Re: Response to Deficiency
Abandonment of Well S-2-GW
Savage Services Corporation
Savage Coal Terminal
C/007/0022 , Task ID #4445

Title: Response to Deficiency - Removal of Ground Water Monitoring Well S-2-GW

Appendix 7-4
Justification to Remove
Groundwater Monitoring Well S-2-GW

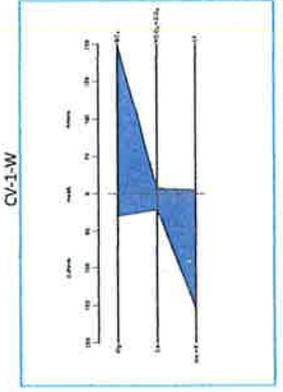
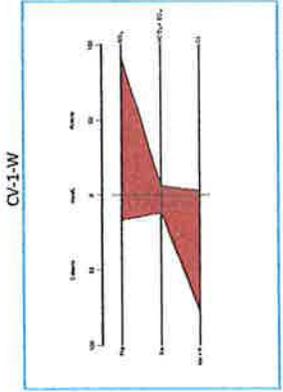
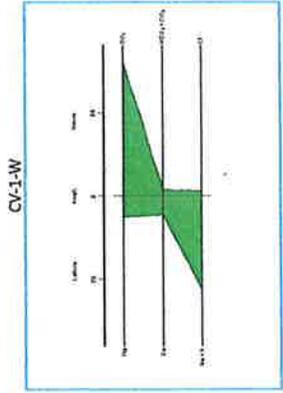
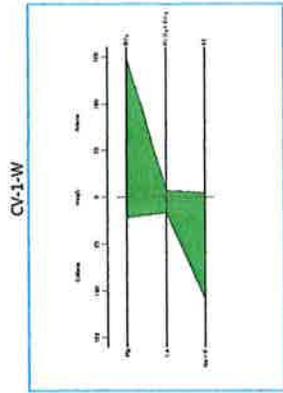
In November 2013, Savage Services Corporation submitted an amendment to the Savage Coal Terminal MRP, requesting approval to abandon Groundwater Monitoring Well S-2-GW. Upon review of the amendment, the Division issued a deficiency requesting more information to justify removal of the well. The deficiency stated in part ...”For the Division to release well S-2-GW the data generated must demonstrate that no impacts were observed. To demonstrate this the applicant shall present and analyze the data from S-2-GW with comparison to other wells and/or historic data”.

Second, the attached Stiff diagrams were prepared to show that general groundwater quality as reflected by data obtained from S-2-GW remains spatially and temporally consistent. Monitoring site CV-1-W is used in the demonstration. As background, the approved MRP demonstrates that shallow groundwater in the area "is generally poor and dominated by sodium sulfate" (MRP Chapter 7, page 10). CV-1-W samples a "French Drain intercepting shallow groundwater flow from the north and west" (MRP Chapter 7, page 10).

Three sets of Stiff diagrams are included. The first compares the four most recent paired samples from CV-1-W and S-2-GW. The second set compares the four earliest paired samples from these two sites (2007-2008). The last set provides data from CV-1-W from the earliest available samples with a complete set of ions analyzed (2000-2001). These Stiff diagrams show that: (1) the dominant cation and anion continue to be sodium and sulfate, respectively; and (2) differences in the proportional makeup of the major ions, either between the two sites or over time, are not distinguishable. Thus, S-2-GW currently appears to be collecting groundwater that has the same quality as when the well was first installed, and which is also the same as that collected currently (and previously) at the French Drain.
